Diablo Canyon Units 1 and 2

Response to NRC Request for Additional Information Regarding PG&E Letter DCL-11-072, "License Amendment Request 11-06, Revision to Technical Specification 3.3.5, 'Loss of Power (LOP) Diesel Generator (DG) Start Instrumentation" dated October 24, 2011

***PG&E Response to NRC Request for Additional Information for  
Diablo Canyon Power Plant Regarding Technical Specification 3.3.5***

4160V BUS SECTION "F" (SEE NOTE 4)

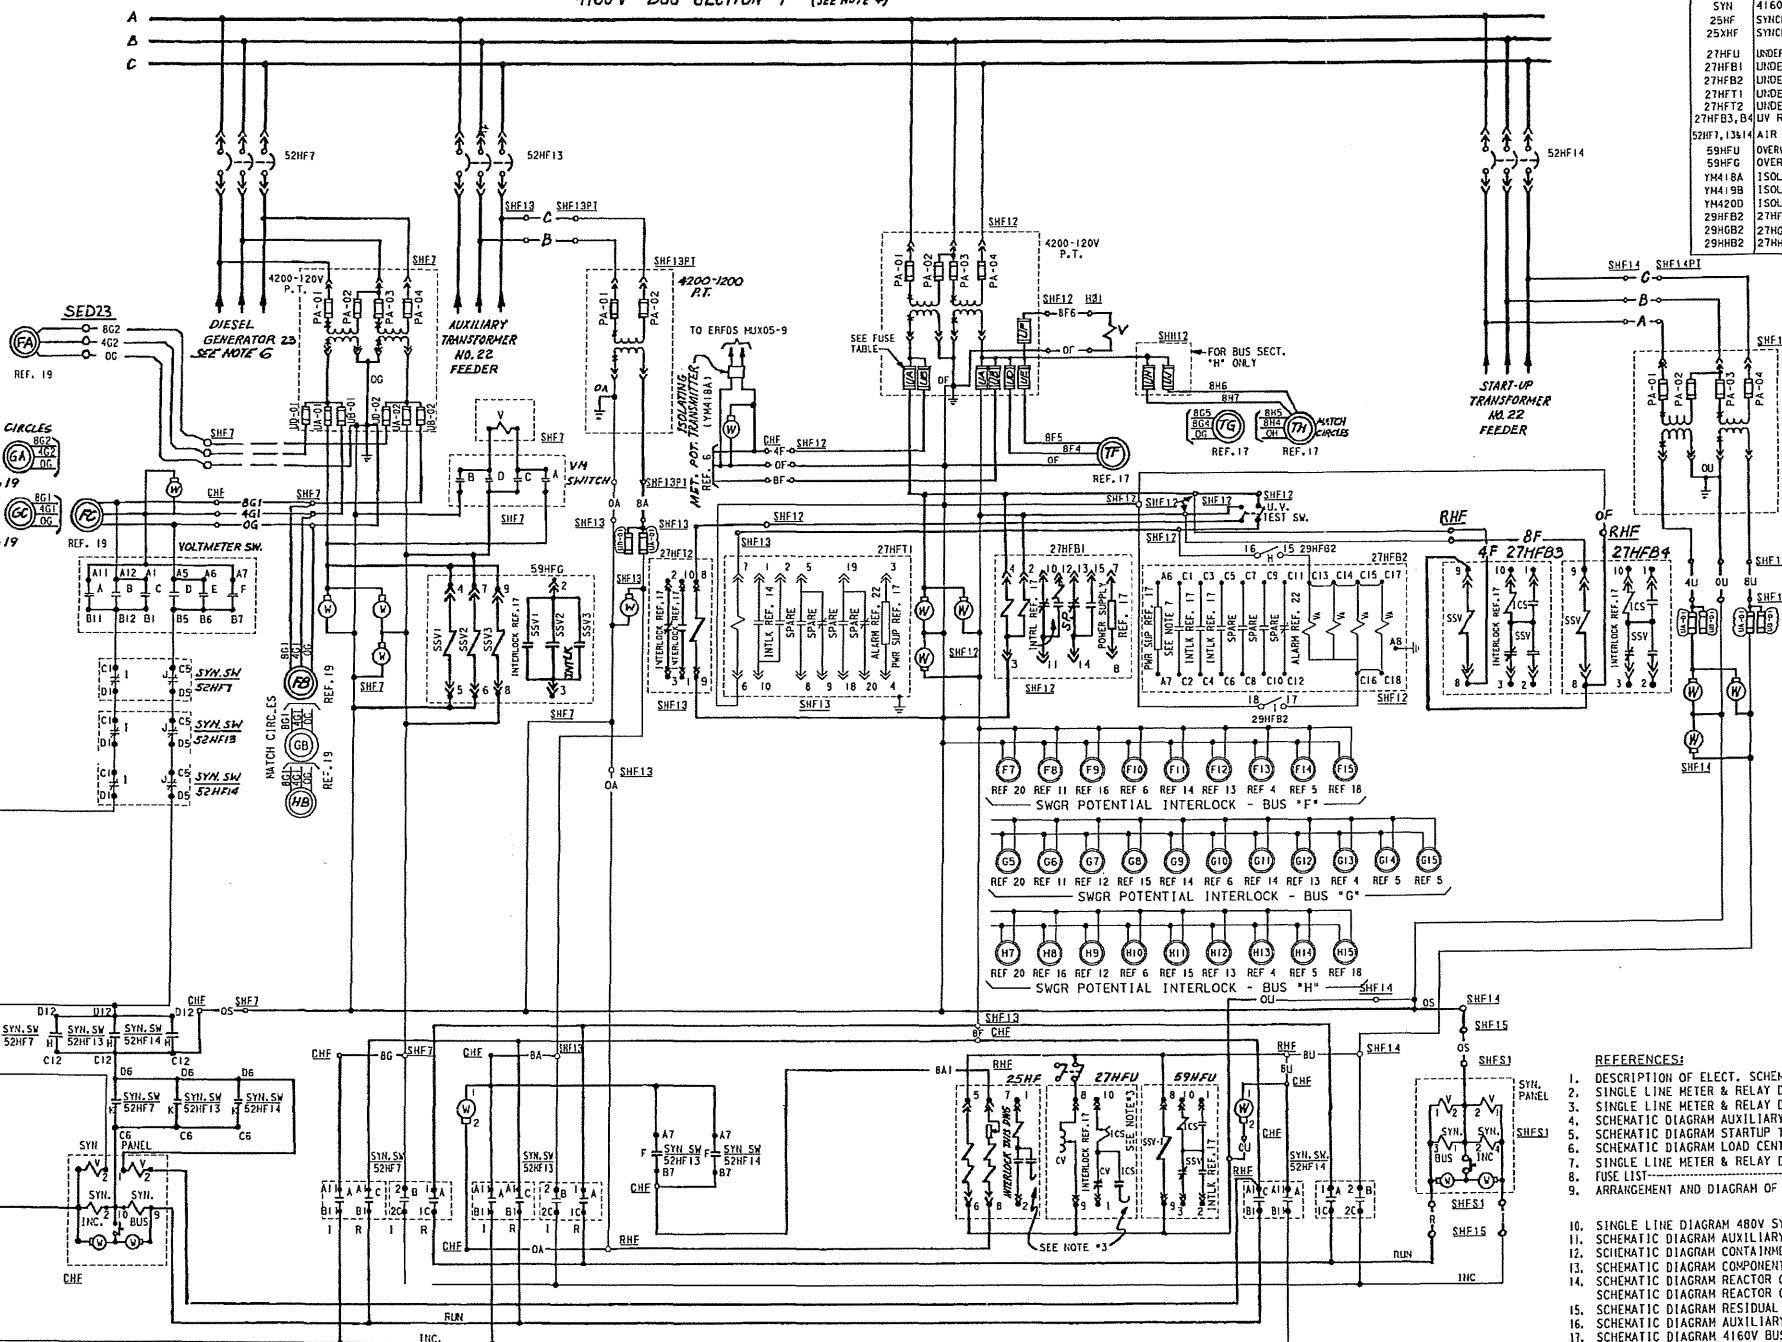
*Please provide diagrams indicating how the different devices described above are connected including the connection of the potential transformers and the relays, to enable the staff to understand the justifications requested above. Indicate what combination of relays are required to ensure that the required protective action is successfully achieved.*

Informational logic diagrams, schematics and connection diagrams are attached to this submittal as listed below. Drawings are stamped "PRELIMINARY FOR INFORMATION ONLY" as the design change to implement the new protective logic is still in the development phase. However the following is not expected to change: logic, coincidence, permissive design, and relay connection.
